COTTONWOOD HEIGHTS PLANNING COMMISSION MEETING AGENDA

Planning Commission Staff Report

Planning Commission Staff Report

PROJECT NAME: CUP-16-005 COTTONWOOD DENTAL S.P.A.

1 SOUTH
1/4" = 1'-0"

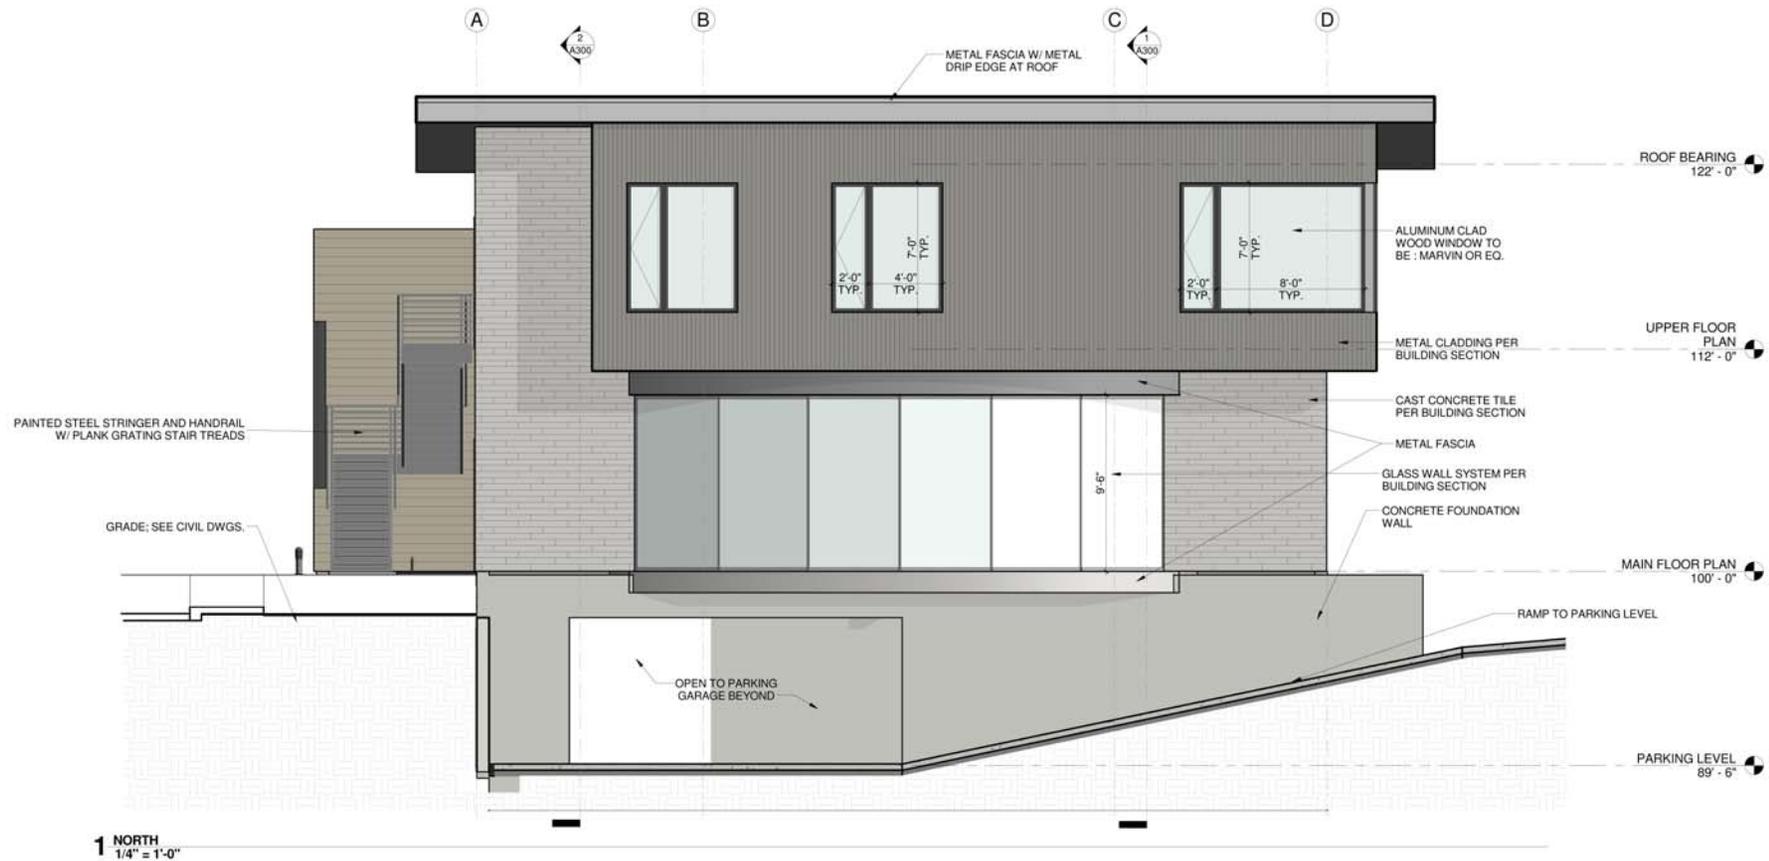
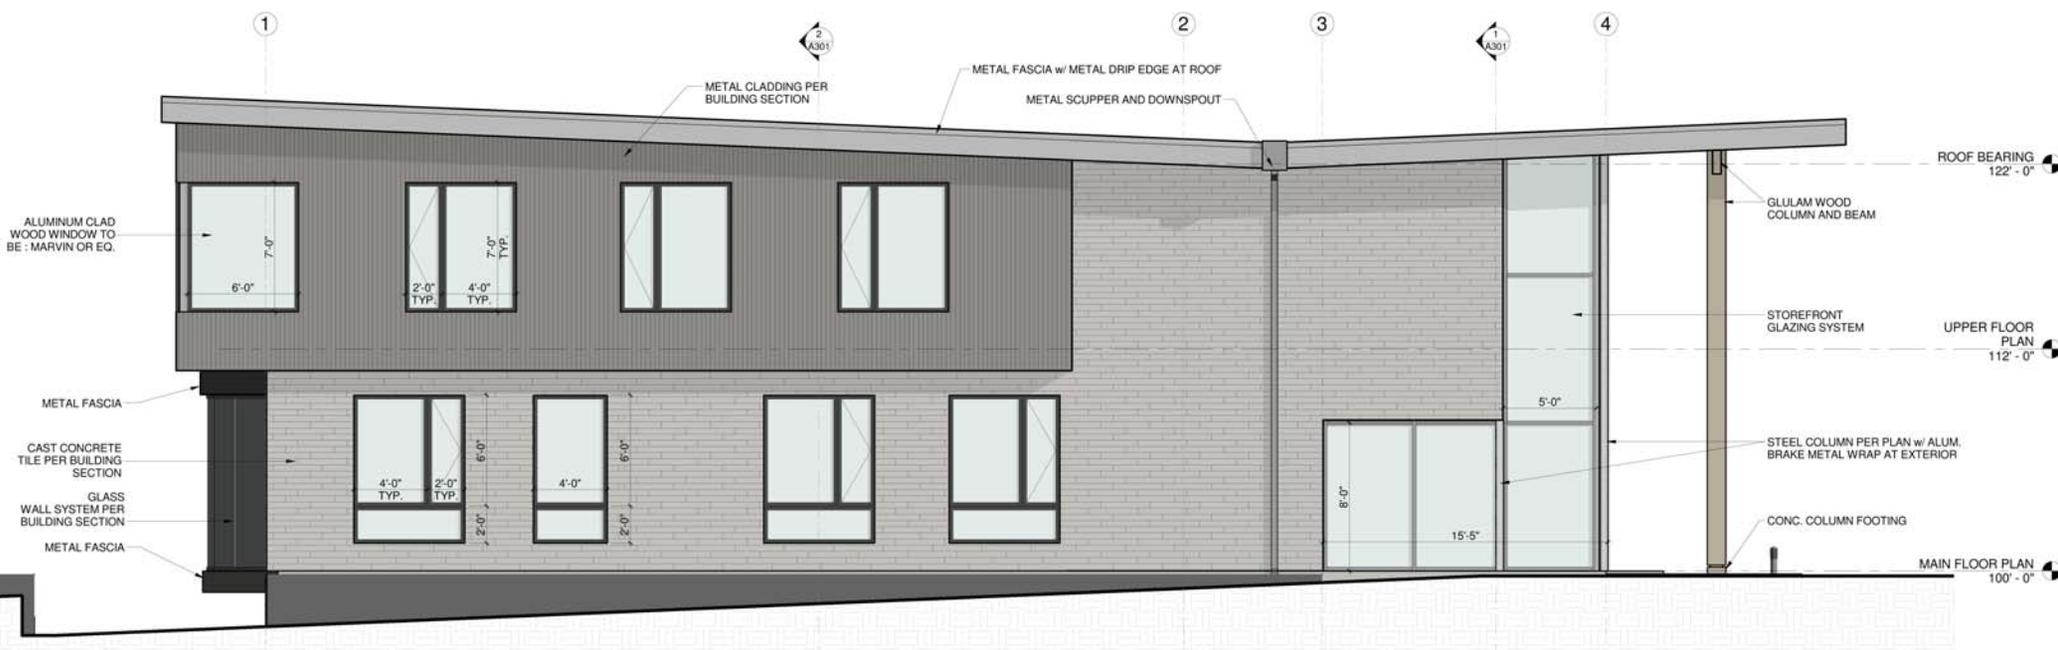
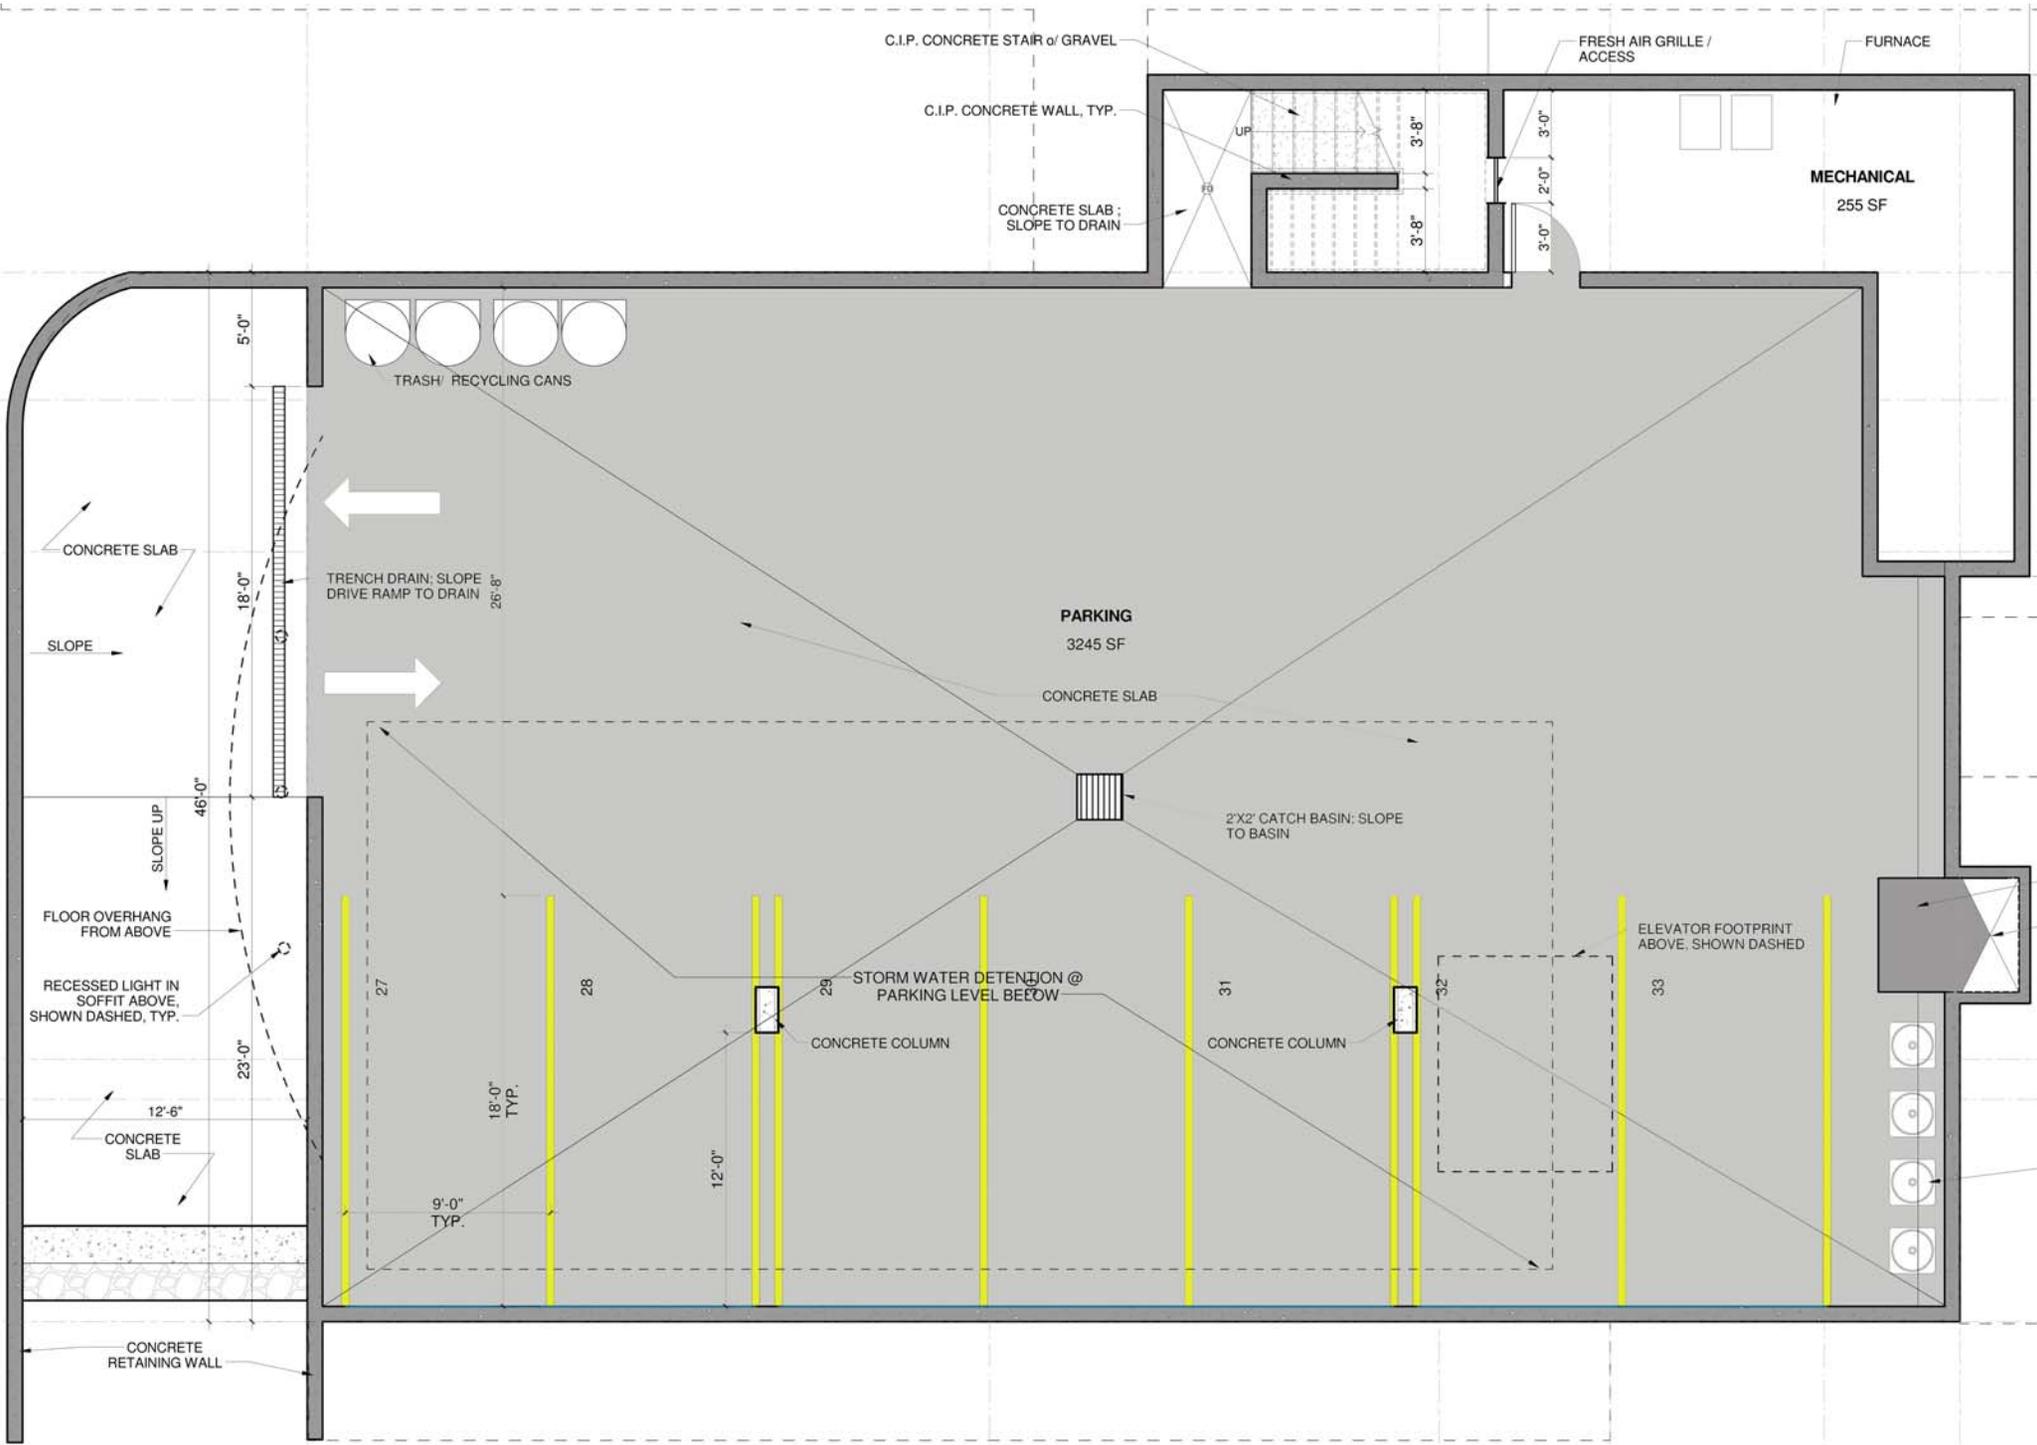
15. All technical corrections to the construction documents shall be made prior to issuance of a building permit, as approved by staff.
16. Revise Grading Plan based on the following comments:

- a. A reinforced 6-inch ADA Sidewalk from frontage shown on site plan does not match that shown on grading plan. Replace existing sidewalk at drive approaches with thickness and specifications to meet APWA.

- b. A significant part of the parking lot & building is not being detained and is currently designed to drain onto Highland Drive. Show areas not detained on the plan set and calculate the flow created by this undetained area. Subtract the undetained flow from the original discharge

requirement. (Allowable Flow = (0.2 cfs * Area) – (Undetained Flow)). This is the new allowable discharge for your development. Please include this in the final calculations.

c. Use Utah APWA standards for all ADA Ramps, SD Improvements and all other site improvements. Provide details on construction plan set.

d. Show elevation of existing 48-inch Storm Drain Pipe on Highland Drive.

h. Provide additional freeboard for detention area on north side of parking lot, where storm water could potentially drain onto adjacent property if system failed.
